AMENDED AND RESTATED DEVELOPMENT AGREEMENT

### Implementation Agreement (Whispering Canyon Punch List Items)

Re: Response to Development Agreement Exhibit "D" Punch List Items

**Re: Whispering Canyon Development Agreement Exhibit 'D' Punch List Item**

Crane/Barnes  
 Catalog: Crane Barnes.60, Vers 4-12  
 Grinder - 3B - 3600  
 Design Point: 29 US gpm, 151.74 ft

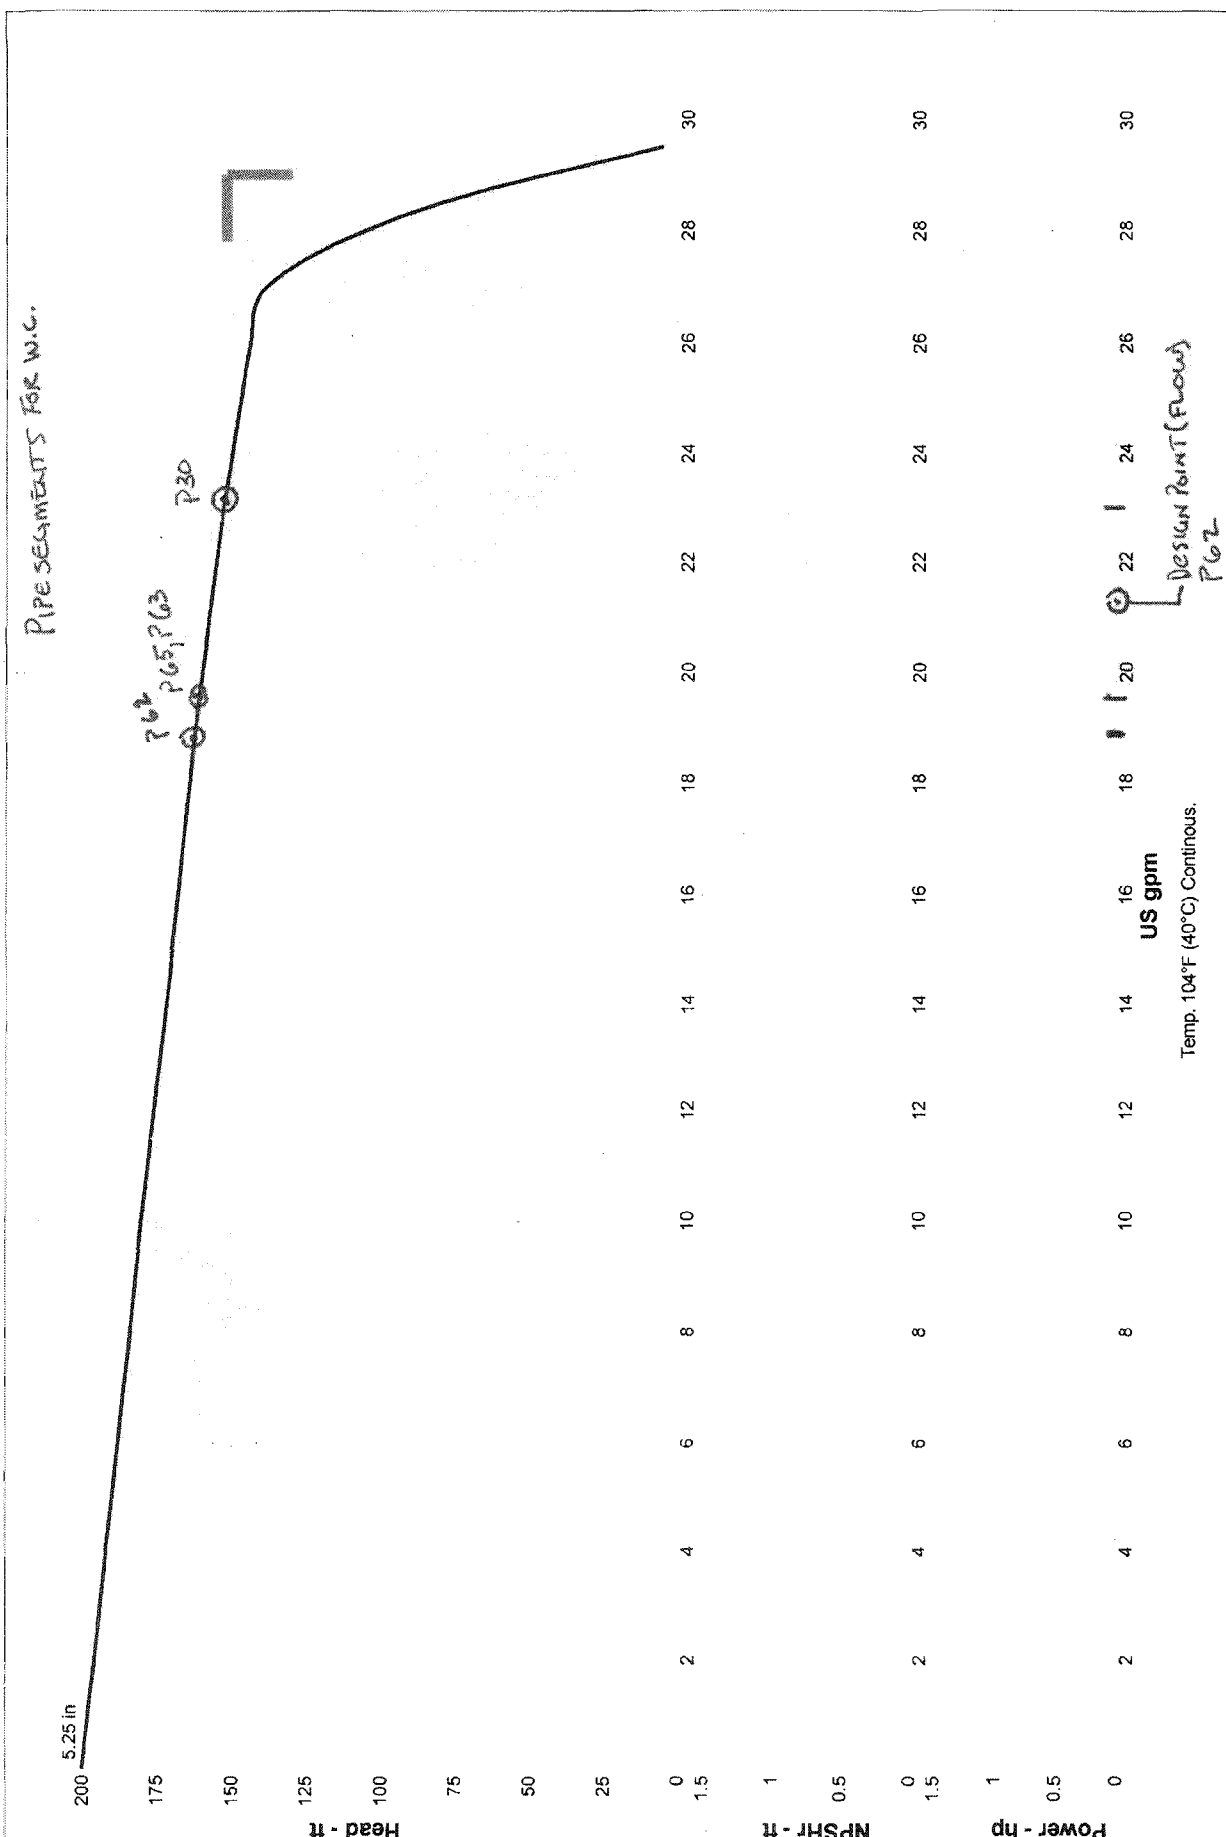
Lyon Engineering has evaluated the Whispering Canyons P.A.D. Phases 1-11 Sewer Analysis to determine if the lots stated within item three of Exhibit "D" will require a higher capacity pump and storage reservoir to service the lots. Each individual Barnes EcoTRAN System is equipped with the standard OGP2022CE pump; this pump is rated for a maximum pressure head of 200 feet. Pipe segment 62, which services lots 151-153 will have the highest total dynamic head pressure (TDH) to overcome at 167.7 feet. The attached pump curve from the manufacture of the OGP2022CE pump was plotted with each pipe segment that was flagged by the report. These items were flagged because the maximum flow could not be achieved due to the TDH. By plotting the design point for pipe segment 62, the pumps within this segment will operate at 19 gallons a minute at 167.7 TDH. Based on the manufacture's pump capacity of the OGP2022CE pump and the attached sewer analysis, the onsite pumps for the lots indicated within Item three of Exhibit "D" are not undersized. These onsite pumps will perform within the manufacture's recommendations.

1. Transfer license for force main gravity main in Power Easement.
2. Manholes – agree to raise 3 manholes on main gravity line to prevent water infiltration.
3. Lots 145-156, 163 & 164 individual onsite pumps undersized. *Prove letter of notice to these lots having a need for more storage, give to Title Company for future escrows and send certified letters to lot owners for lots that have been sold.*
4. Commence efforts to obtain WAPA license transfer or acceptable access authorization.

Based on the updated sewer analysis for WC and the manufacture's pump curve, the low pressure sewer system will operate within the manufactures recommendations, and notices for the lots identified in Item three of Exhibit "D" will not be required.
